8-10 Barry Road North Kellyville

PREPARED FOR BATHLA GROUP

Proposed Modification seeks amendments to the approved architectural plans to reflect the upgraded design, and improve the design and amenity of the buildings

ground floor plan

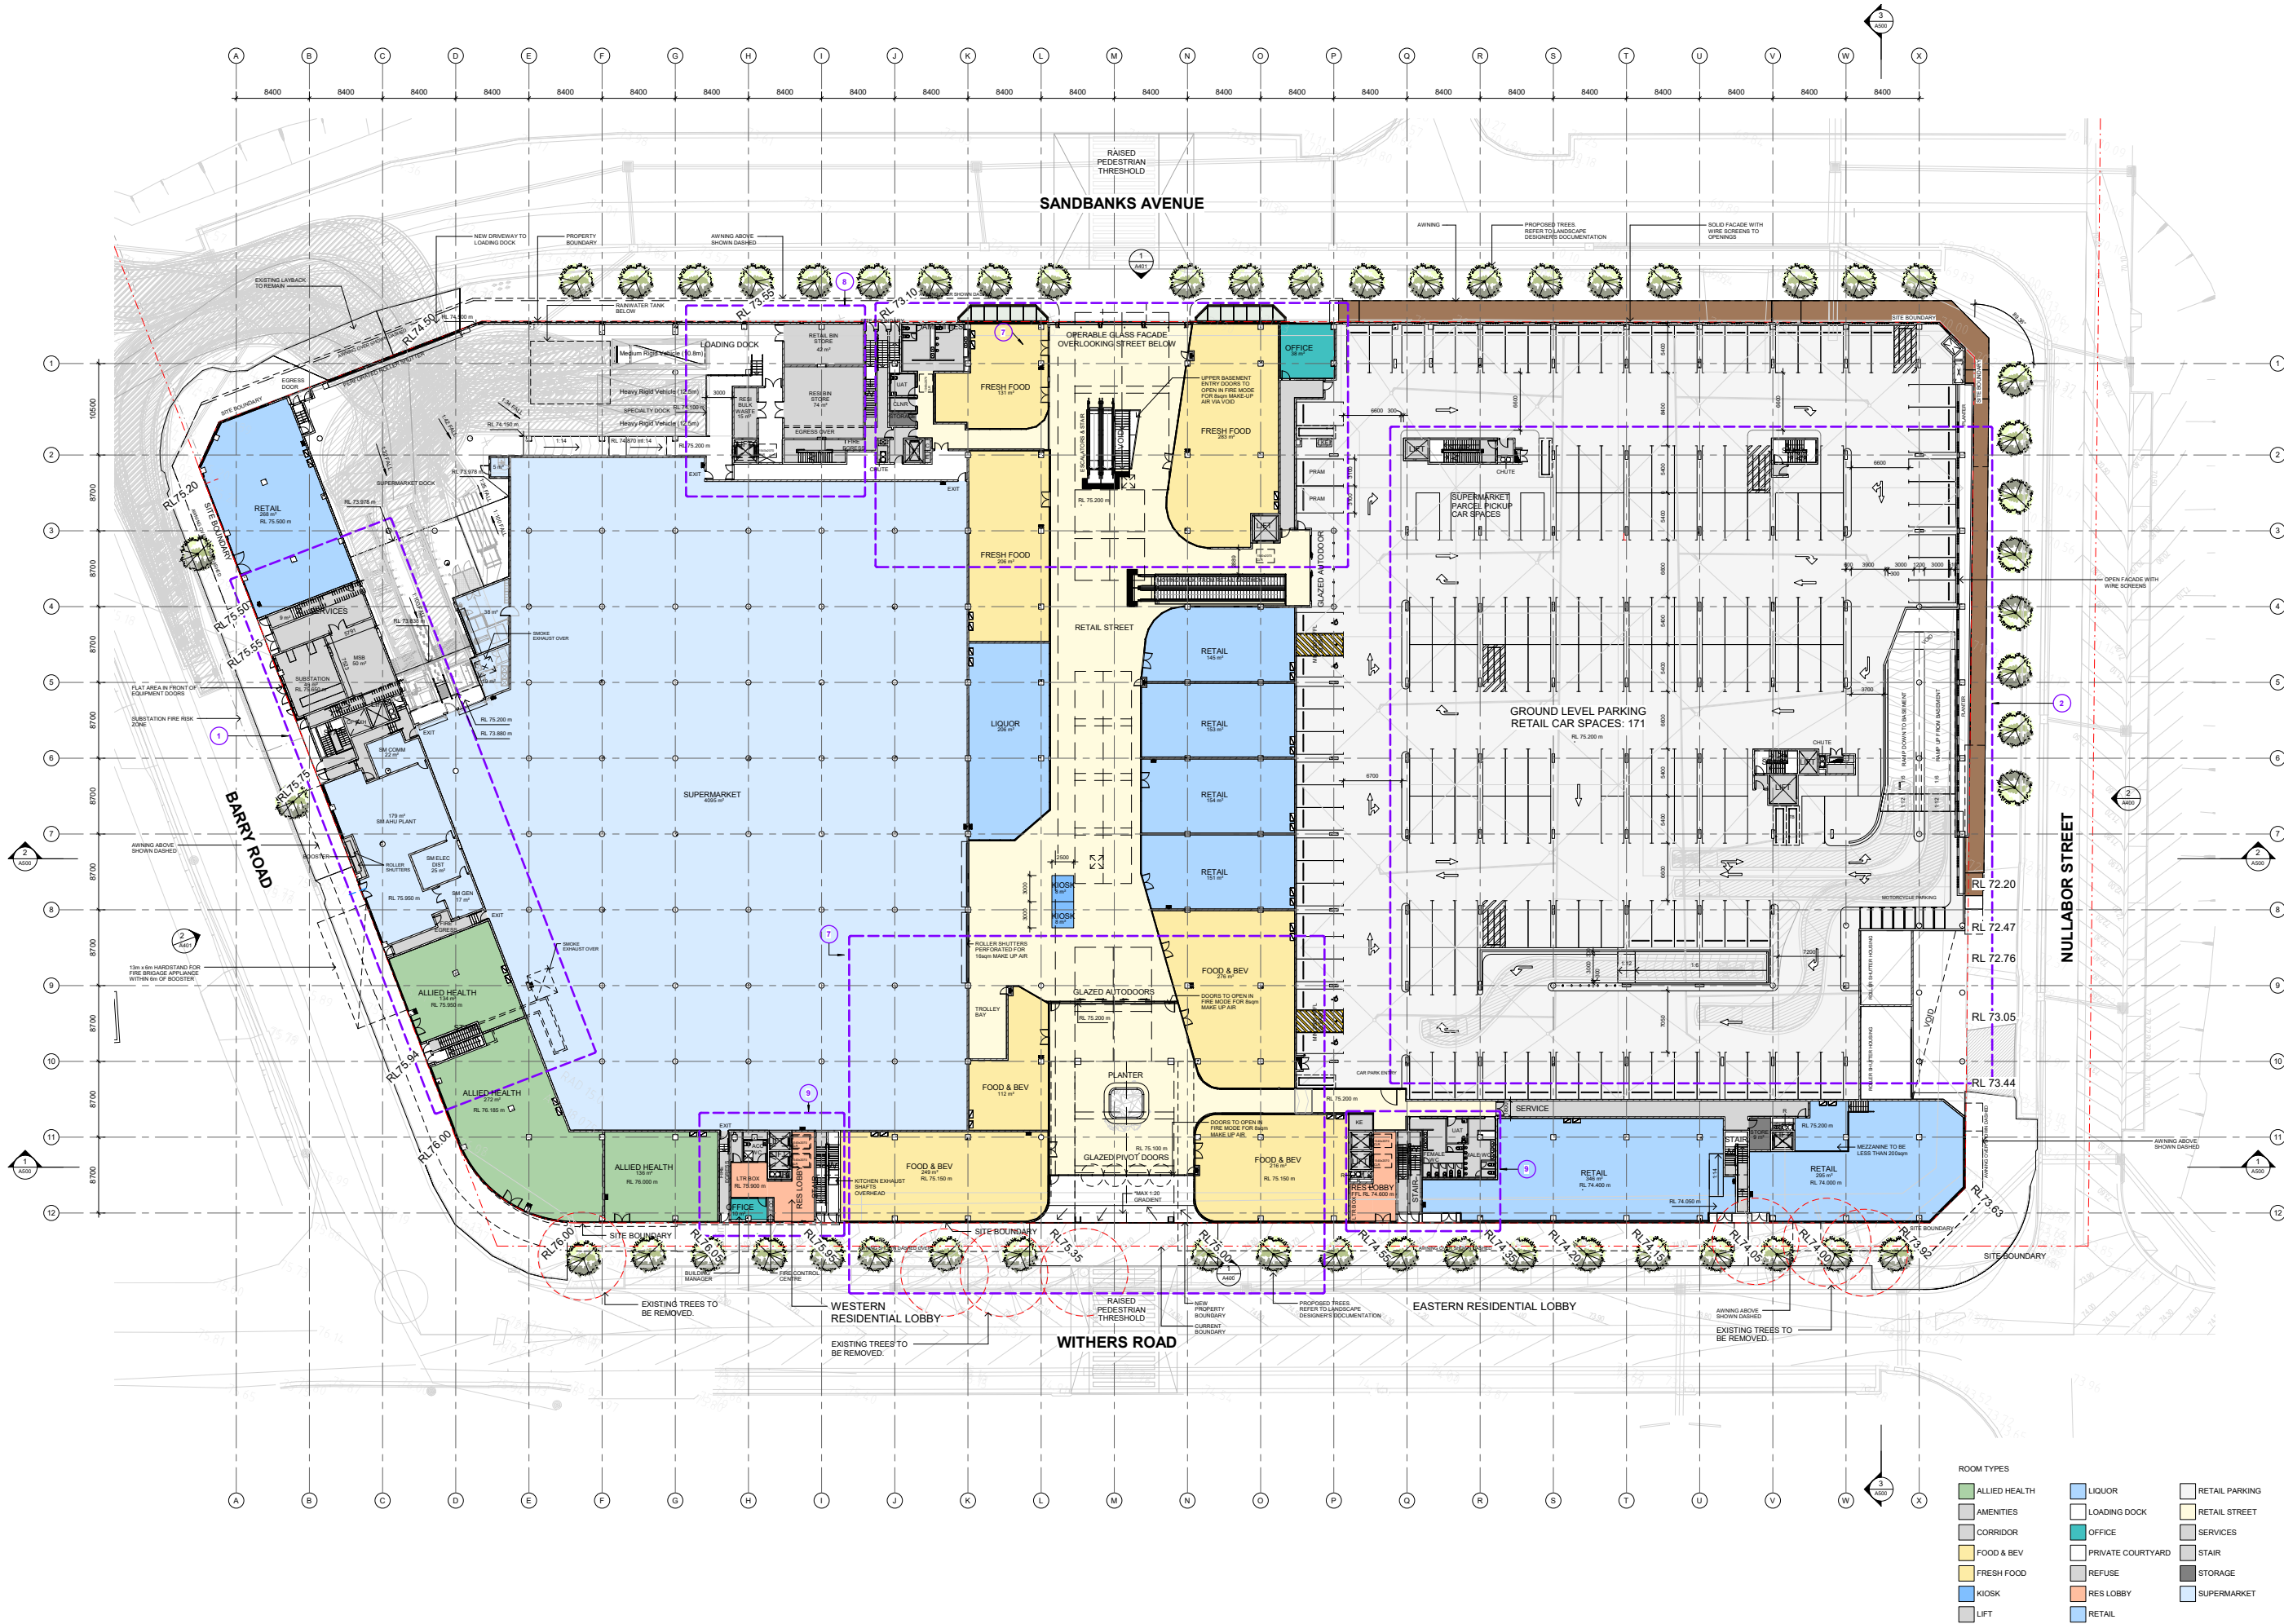
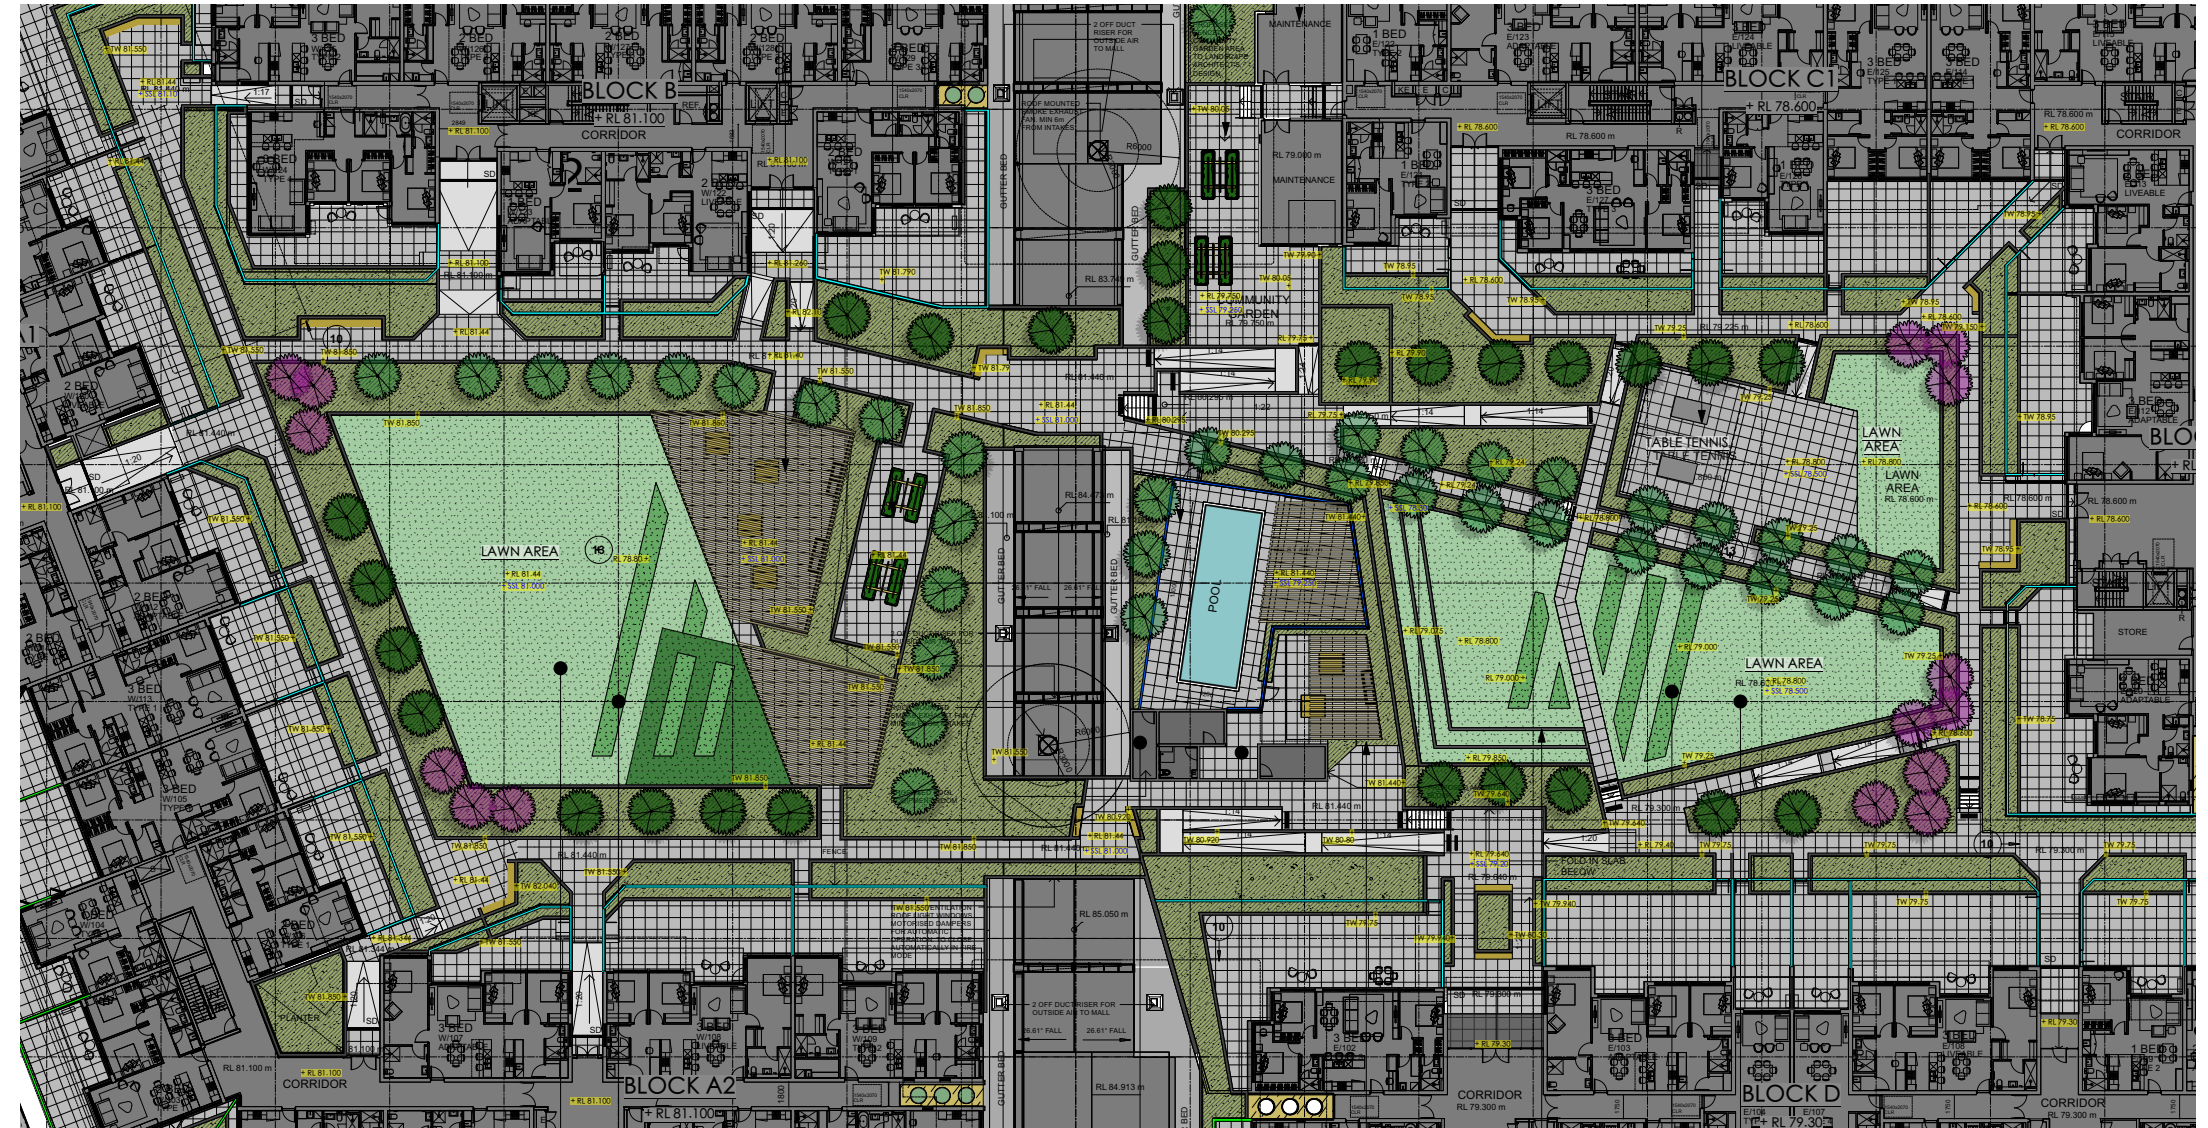
1	SERVICES RELOCATED FROM NORTHERN TO WESTERN SIDE OF BUILDING
2	CANPARK CIRCULATION IMPROVED
3	CANPARK CANOPY RELOCATED
4	MEETINGS FOR COMMUNITY MEETING ROOM ADDED
5	RAMP ACCESS TO COMMUNITY MEETING ROOM PROVIDED FROM STREET IN ADDITION TO ACCESS FROM CANPARK
6	PROPOSED CAR PARK ENTRY/EXIT & DRIVEWAY DELETED SHOWN WITH DASHED LINES AND STREET LEVEL RETAIL ADDED IMPROVING SANDBANKS AVENUE ACTIVATION
7	PATRON CIRCULATION IN RETAIL STREET IMPROVED
8	RESIDENTIAL AND RETAIL WALKWAY STORAGE ADDED
9	RESIDENTIAL LOBBY ACCESS FROM TWO GROUND FLOOR LOCATIONS
10	BUILDING SEPARATION DISTANCES REDUCED IN KEEPING WITH A.D.S
11	RETAIL STREET ROOF DESIGN AMENDED FOR IMPROVED FLOOD OUTCOMES
12	APARTMENT LAYOUTS AMENDED IN KEEPING WITH A.D.S TO IMPROVE SOLAR ACCESS AND CROSS VENTILATION
13	POULAM LANDSCAPE DESIGN IMPROVED
14	EXTENT OF BIRNING MEETINGS
15	PRIVATE STAIRS ADDED TO BALCONIES FOR ACCESS TO PRIVATE ROOFTOP TERRACES

16	PRIVATE ROOFTOP TERRACES ADDED
17	GENERAL NOTE - UNIT NUMBER INCREASED, UNIT MIX AMENDED
18	FINISHES AMENDED TO IMPROVE RESPONSE TO SITE
19	FLOORS TO FLOOR HEIGHT OF RESIDENTIAL APARTMENT LEVELS INCREASE FROM 3m TO 3.1m
20	FLOOR LEVELS MODIFIED - VENTILATION, FACADE MODIFICATION, LOBBIES & EXITS REVERSED
21	FLOOR LEVELS OF EXISTING AND GROUND FLOOR LOWERED TO IMPROVE HEADROOM
